Intel[®] Mobile Celeron[™] Processor Specification Update

Release Date: January 2000

Order Number: 244444-011

Figure 2. Workaround Flowchart: SMBALERT#-Driven System

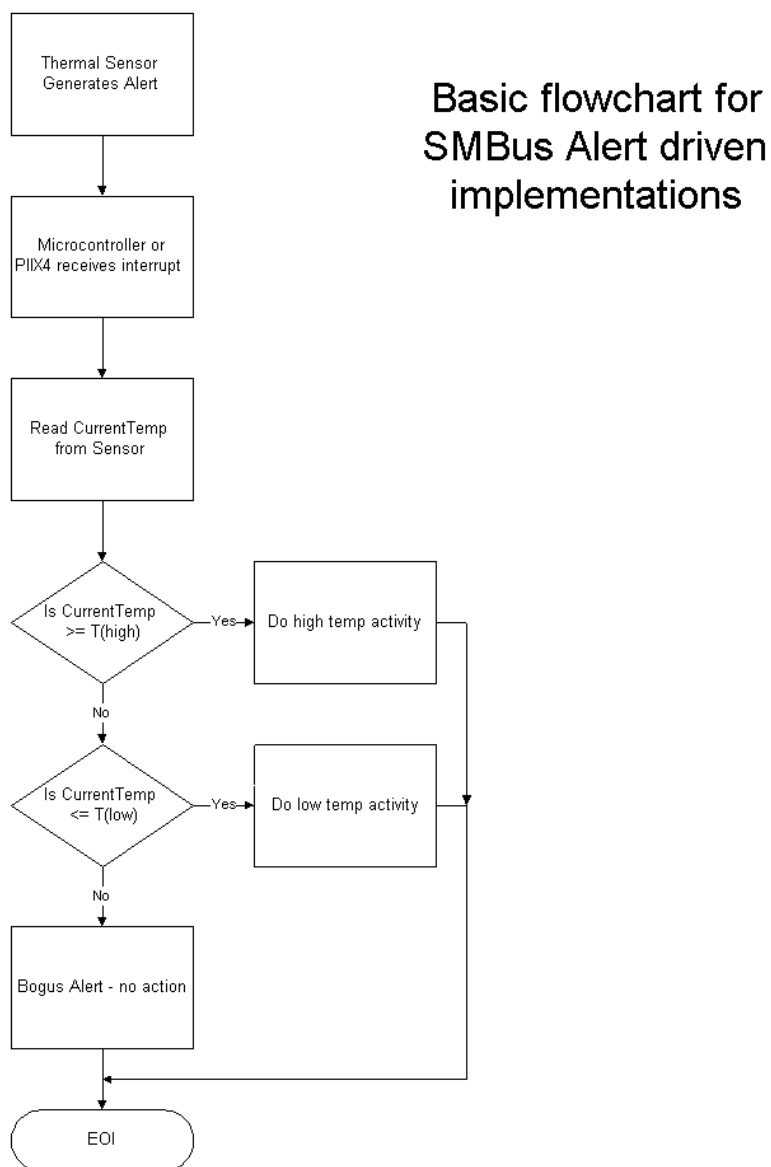
Workaround: Three different (mutually exclusive) workarounds are possible:

1. Before servicing an interrupt from the thermal sensor, read and compare the processor thermal reading with the threshold limits (T_{HIGH} or T_{LOW}). Figures 2 and 3 provide basic flowcharts for the implementation of this workaround in an interrupt driven system.
2. If the firmware implemented polls the Status Register only, then before taking any action, re-read the temperature register and do a comparison with the alarm threshold limits (T_{HIGH} or T_{LOW}) to determine if the value is actually still within the temperature window.
3. Use a temperature polling scheme to monitor the processor temperature.

Figure 5.3. Surface-Mount BGA1 Package—Top and Side View

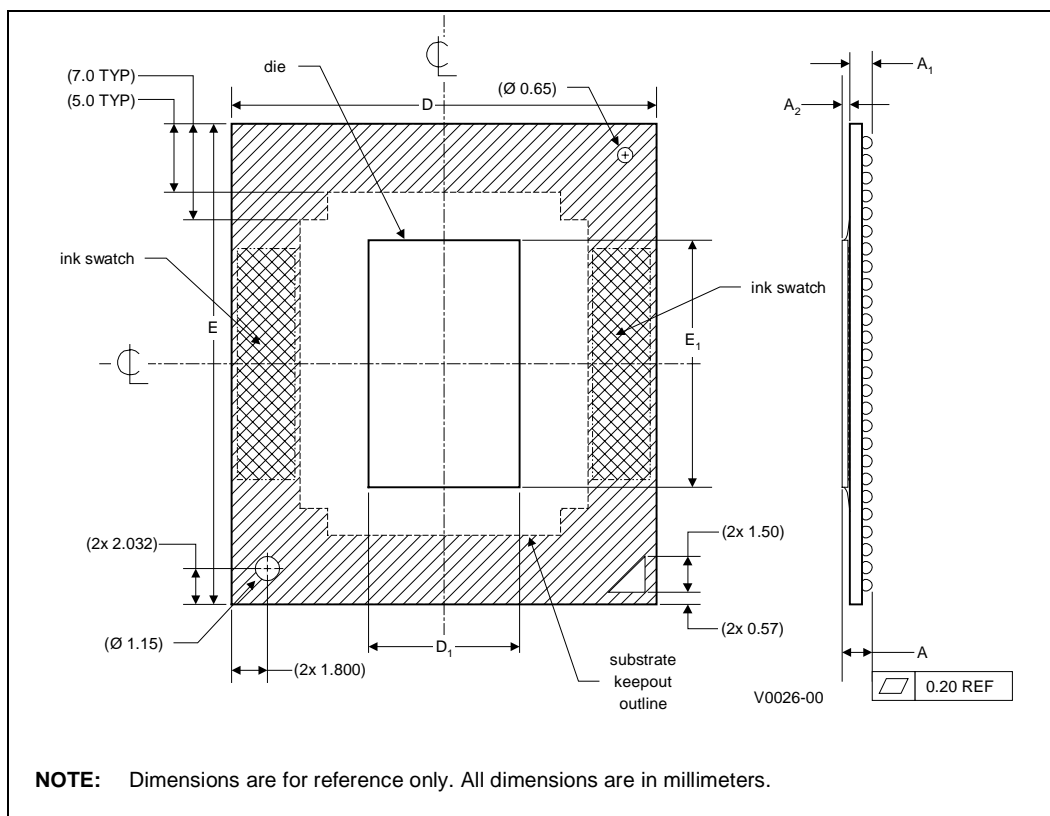
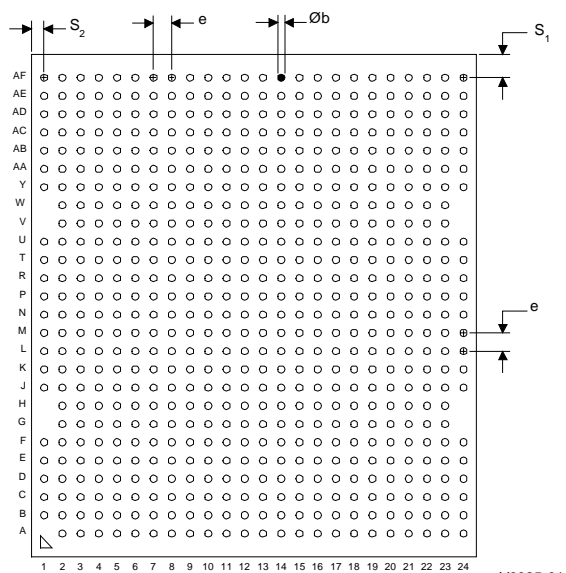
The following table and figures show the updated mechanical specifications for the BGA1 package, listed as Table 5.2, Figure 5.3 and 5.4, respectively, in the *Intel® Mobile Celeron™ Processor in BGA Package at 333 MHz, 300 MHz and 266 MHz* datasheet.

1. The number shown here is different from that in the 244444-004 version of this specification update. The maximum reference number is used.

Figure 3.3 Generic Clock Waveform

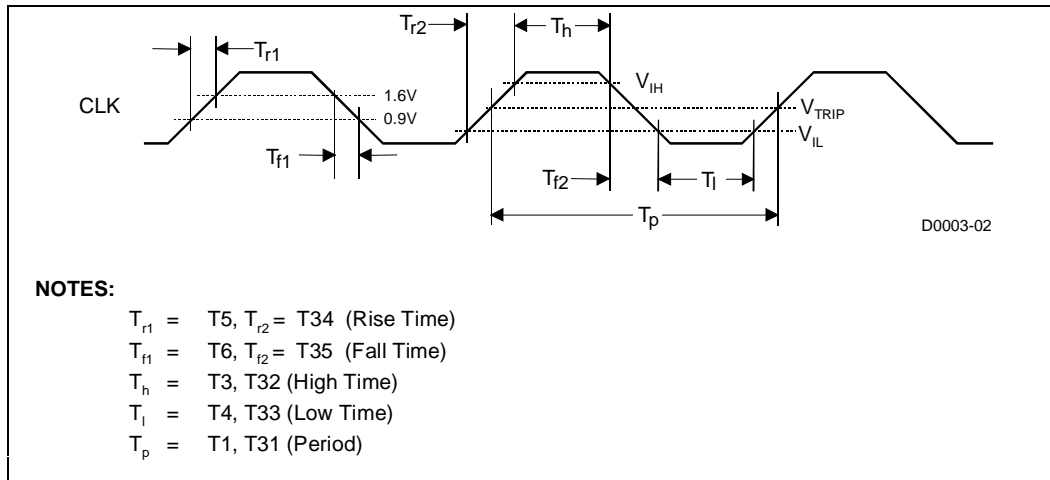
H11. Generic Clock Waveform Figure

Figure 3.3 in the *Intel® Mobile Celeron™ Processor in μ PGA1 and BGA1 Packages at 366 MHz, 333 MHz, 300 MHz, and 266 MHz* datasheet (Order Number 245112-003) has been updated. The following figure is to replace the one in the above document.
